## **JACOBSEN SUBDIVISION**

**DESIGN EXCEPTION**

Re: Design Exception 24-06 – 738 26 Road (Jacobsen Subdivision)

## DESIGN EXCEPTION 24-06

JACOBSEN SUBDIVISION  
DESIGN EXCEPTION  
EXHIBIT 5

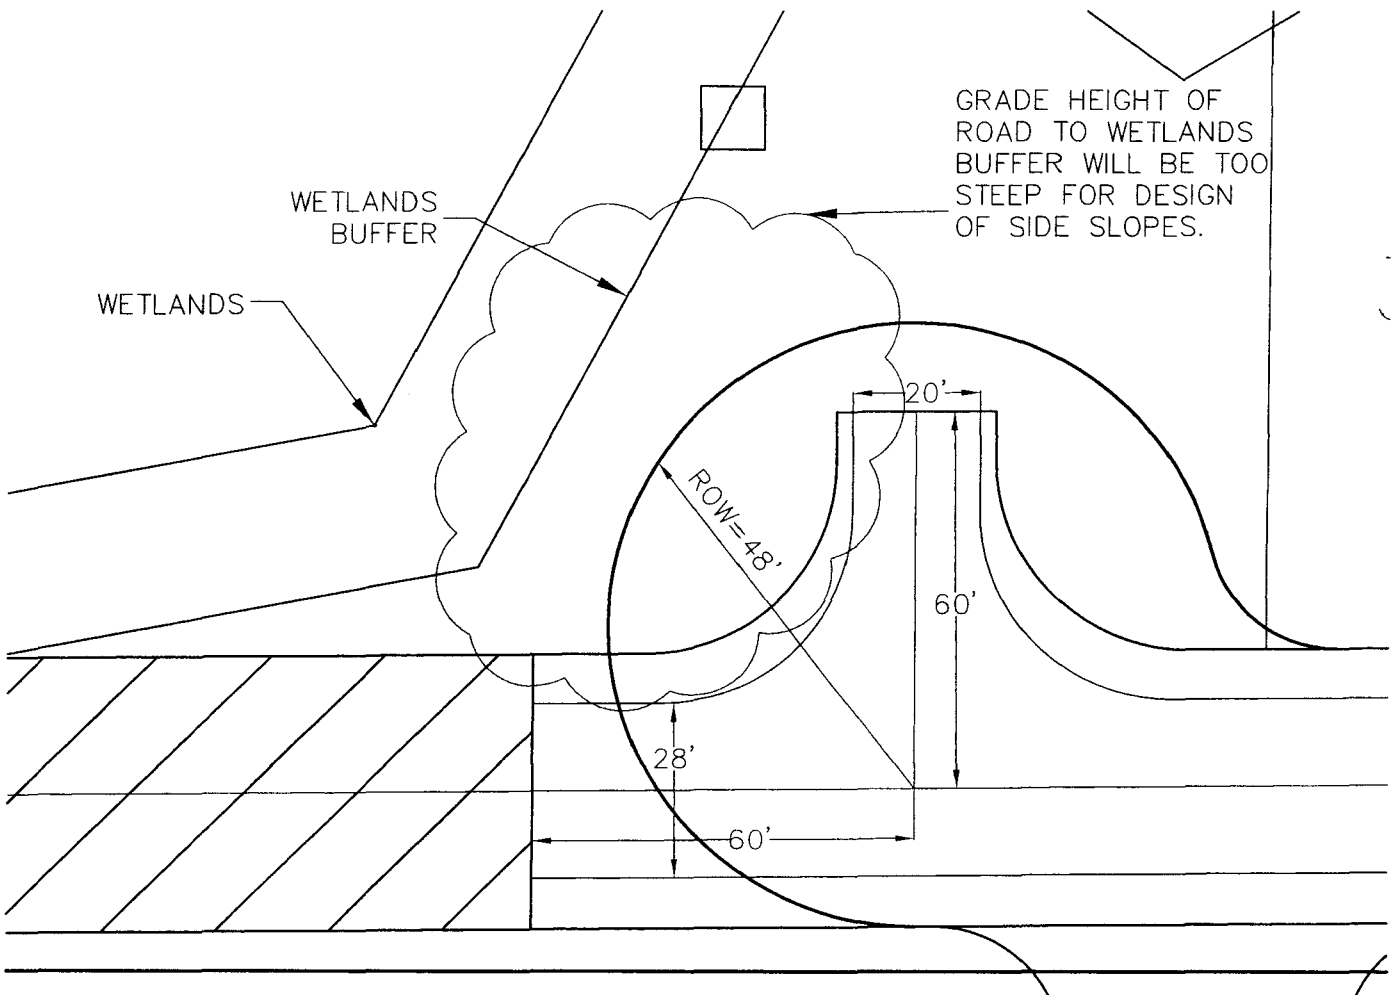
At the end of the cul-de-sac outlined in Design Exception 1, the current site plan has a hammerhead turn-a-round rather than a traditional cul-de-sac. It is not clear from the TEDS Manual if a traditional cul-de-sac is required for a dead end street or if a hammerhead turn-a-round can be utilized as an alternative. At the Pre-Application meeting with city staff, Eric Hahn suggested that a TEDS Exception for the hammerhead should be submitted to make sure the concept is acceptable prior to moving forward with a Preliminary Plan application. Exhibit 5 shows both the proposed hammerhead turn-a-round and a traditional cul-de-sac.

First, the hammerhead has been designed to conform to the requirements of Fire Department Access section of the TEDS Manual. More specifically, the hammerhead shown represents the Alternative Turnaround. In addition, the hammerhead is wider than required along the residential street portion of the turn-a-round. Therefore, the hammerhead turn-a-round does not create any problems in regards to emergency access.

Second, a traditional cul-de-sac will conflict with the wetlands as shown on Exhibit 5. The applicant will be required by permit with the Army Corp of Engineers to provide a 25-foot buffer around the delineated wetlands shown on the exhibit. The grade difference between the wetlands and the probable street

The applicant proposes to construct a hammerhead turnaround on the dead end street, rather than the typical cul-de-sac bulb. The existing wetlands constrict the available area, and the applicant does not wish to lose a lot.

Staff does not believe this specific area will present safety issues. When development occurs on the lot to the south and the southern connection is complete, this turn around will no longer be needed.

Yes. It is possible to construct a typical cul-de-sac bulb. The resulting geometry may (or may not) require the loss of one lot.

The TEDS Committee approved this request as proposed.
